October 17,2025

Notice for change to Laser Marking for POSCAP

■ **Comparison table**

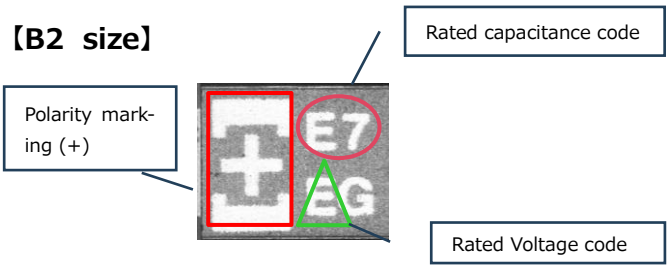
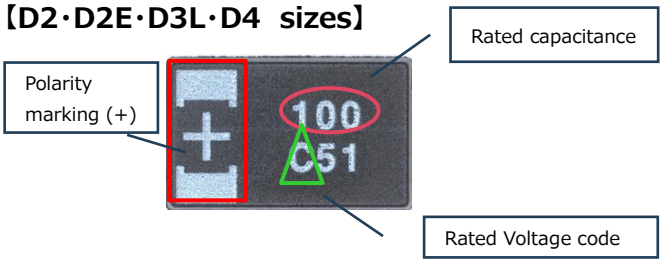
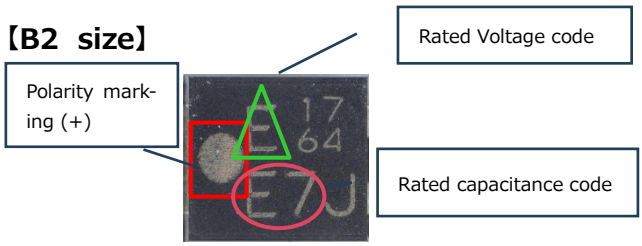
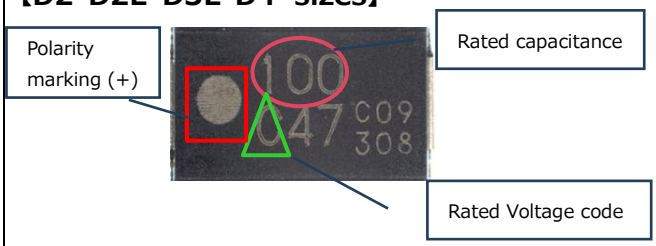
・The product marking method will be changed from UV ink to laser marking.
・The change will be implemented via a running change
Please refer to the table below for details of the marking changes.

Current Specification	After Change
UV ink marking display	Laser marking display
Marking examples for each size **【B2 size】**  **【D2･D2E･D3L･D4 sizes】**  	Marking examples for each size **【B2 size】**  **【D2･D2E･D3L･D4 sizes】** 
Traceability Only the production month can be specifically identified.	**Traceability** It is possible to narrow down by production lot.
The change is limited to the stamping specifications, and there will be no impact on product characteristics or durability.
